Access Compliance Report Public Rights-of-Way (Curb Ramps)

Intersection ID: 16161 Main Street: E_INDEPENDENCE_BV Cross Street: CHARLESTON DR Location: N

ADA ID: D5F88942DFED Ramp Type: Perp Initial Pass/Fail: Fail Overall Compliance: No Severity Score: 12.5

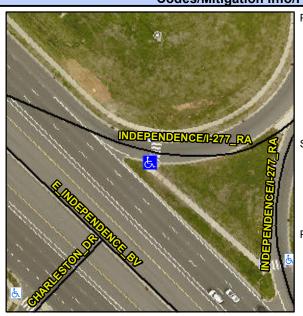
Not Found, R304.2.2

Field Measurements/Component Compliance					
Compliance Description		Data	Comp	liance Description	Data
N/A	Ramp Length (in)	72.0	No	Ramp Slope (%)	8.6
Yes	Ramp Width (in)	48.0	Yes	Ramp XSlope (%)	1.5
N/A	Flare Type LT	N/A	N/A	Flare Type RT	N/A
N/A	Flare Slope LT (%)	N/A	N/A	Flare Slope RT (%)	N/A
N/A	Flare Traversable LT?	N/A	N/A	Flare Traversable RT?	N/A
N/A	Landing Length (in)	N/A	N/A	DWS Provided?	N/A
N/A	Landing Width (in)	N/A	N/A	DWS Contrast?	N/A
N/A	Landing Slope (%)	N/A	N/A	DWS Length (in)	N/A
N/A	Landing X Slope (%)	N/A	N/A	DWS Full Width?	N/A
N/A	Landing Curb? (Y/N)	N/A	N/A	DWS Offset (in)	N/A
N/A	Shared Landing?	N/A			
N/A	Gutter Ponding?	N/A	N/A	Gutter Slope (%)	N/A
N/A	Gutter Lip Ht (in)	N/A	N/A	Gutter X Slope (%)	N/A
N/A	Painted X Walk1?	Yes	N/A	Painted X Walk2?	N/A
	X Walk 1 Direction	To N		X Walk 2 Direction	N/A
N/A	X Walk 1 Width (in)	120.0	N/A	X Walk 2 Width (in)	N/A
	X Walk 1 Slope (%)	2.3		X Walk 2 Slope (%)	N/A

Remove & Replace Entire Ramp.
